**AGENDA  
PLANNING COMMISSION OF THE  
CITY OF WHITE BEAR LAKE, MINNESOTA  
MONDAY, OCTOBER 30, 2023  
7:00 P.M. IN THE CITY HALL COUNCIL CHAMBERS**

**TO:** The Planning Commission  
**FROM:** Ashton Miller, City Planner  
**DATE:** October 30, 2023  
**SUBJECT:** Heartland Gun Club Conditional Use Permit, 4350 Centerville Road,  
 Case No. 23-27-CUP

**To:** Ashton Miller, City Planner  
**From:** Nate Christensen, P.E., Assistant Engineer  
Connie Taillon, P.E., Environmental Specialist/Water Resources Engineer  
**Date:** October 11, 2023  
**Subject:** Heartland Twin Cities Gun Club and Range Engineering Review Comments

1 GRADING, DRAINAGE, AND EROSION CONTROL PLAN  
C100 1"=20'

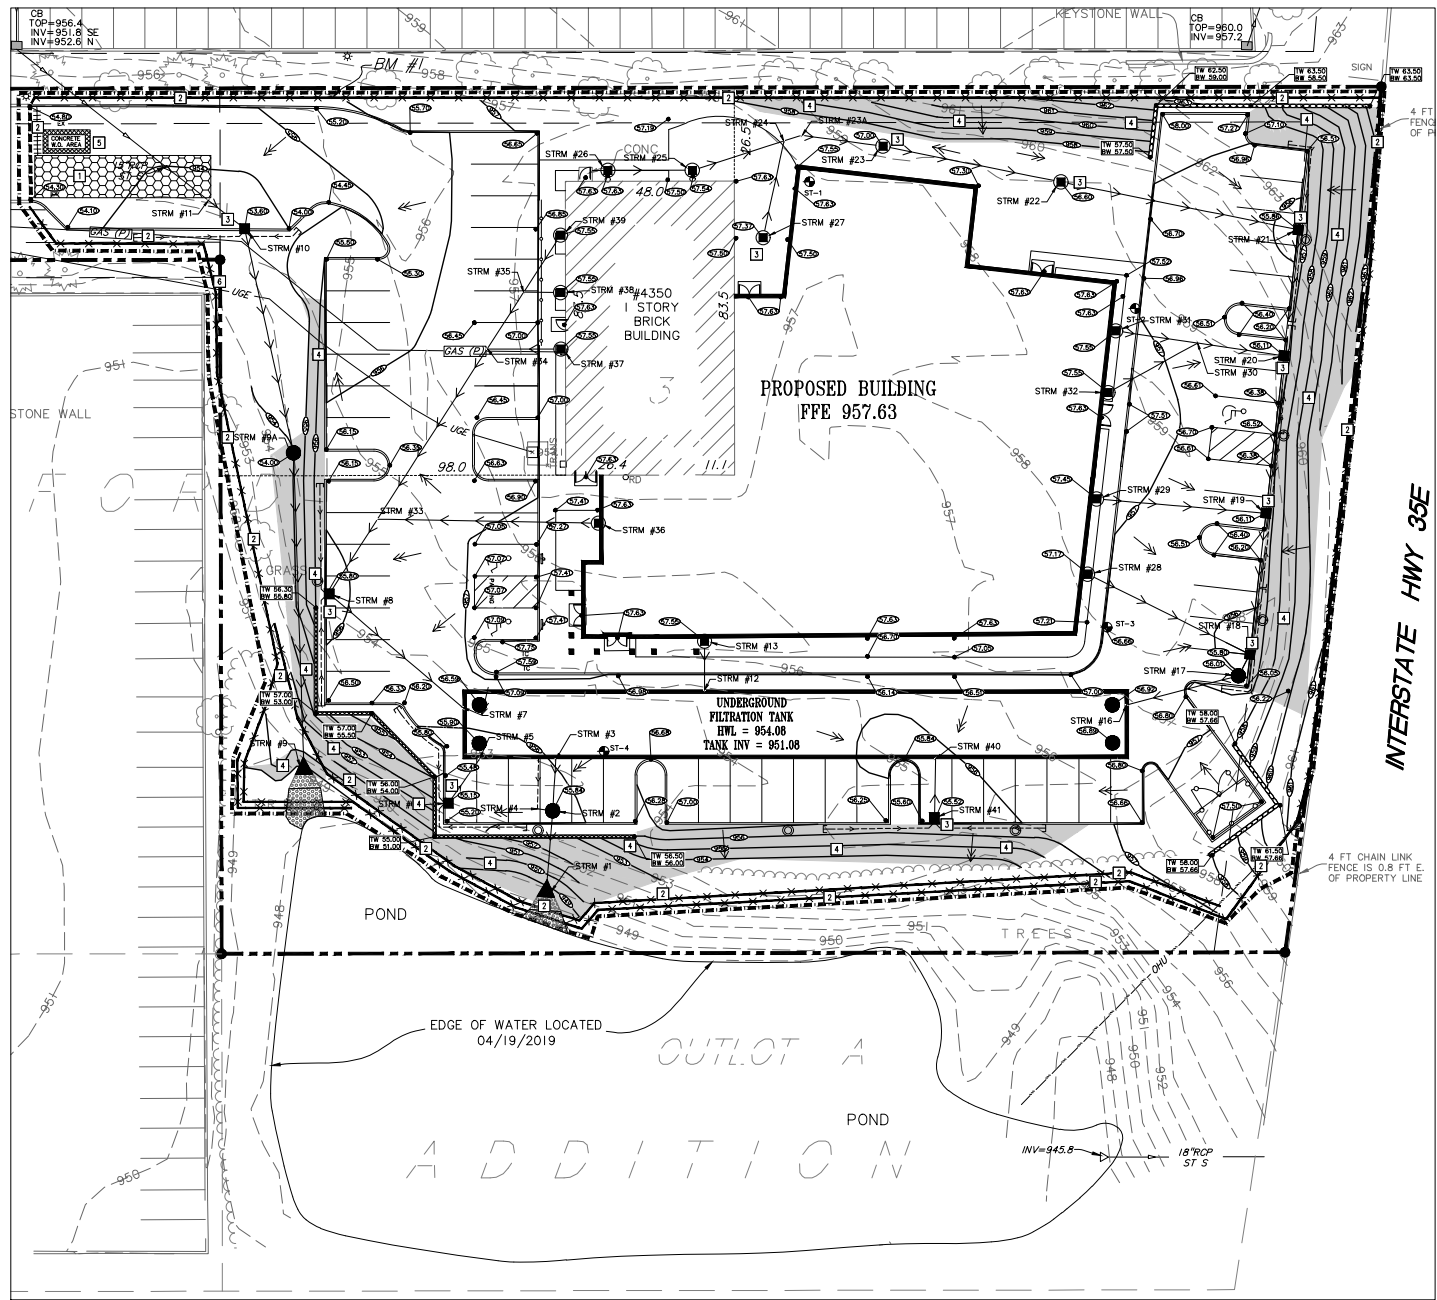
- 6) Label the drainage and utility easements.
- 7) Include the FFE of the existing building on the plan.
- 8) Provide documentation that the proposed building floor elevation meets the City's freeboard requirements for the existing pond.
